Conversion of existing residential into 1x1 bedroom maisonette and 1 x 3 bedroom maisonette (Class C3) 2011/6294/INVALID

56 Huntley Street,
London,
WC1E 6DD

For University College London Hospitals Charity (UCLHC)

Supporting Information

1.3.6 Mansard roof Section

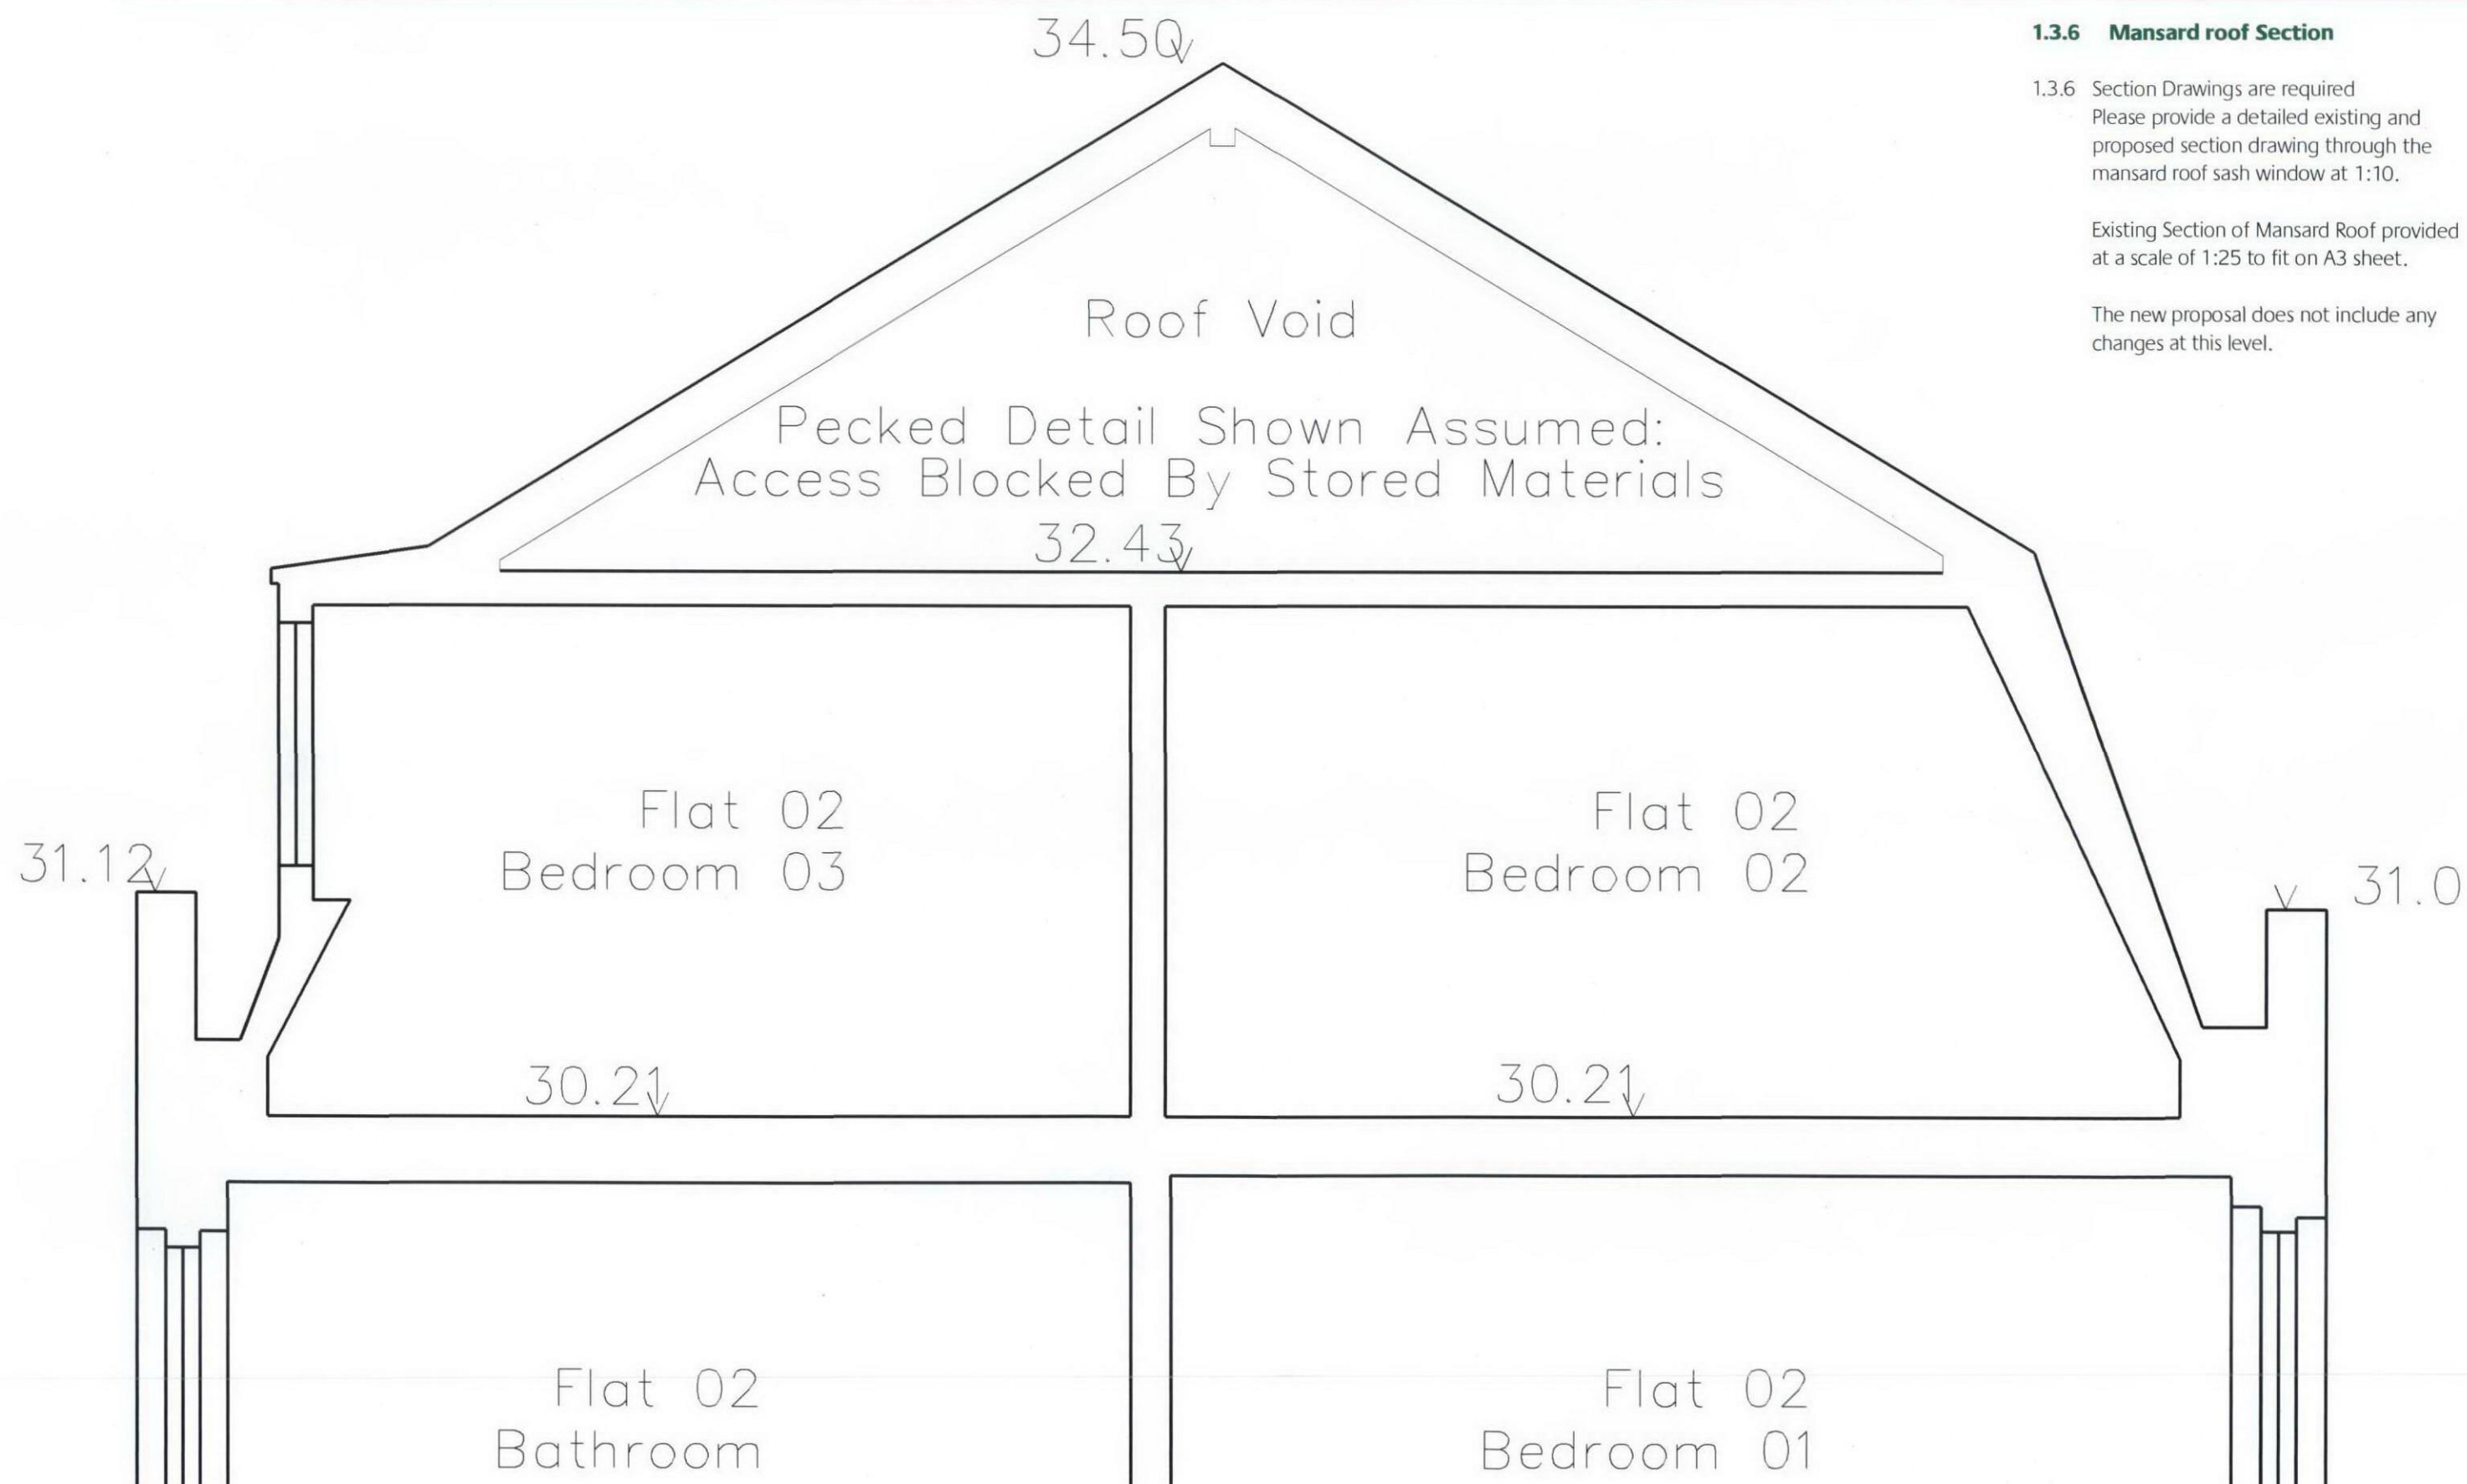
1.3.6 Section Drawings are required
Please provide a detailed existing and
proposed section drawing through the
mansard roof sash window at 1:10.

Existing Section of Mansard Roof provided
at a scale of 1:25 to fit on A3 sheet.

The new proposal does not include any
changes at this level.
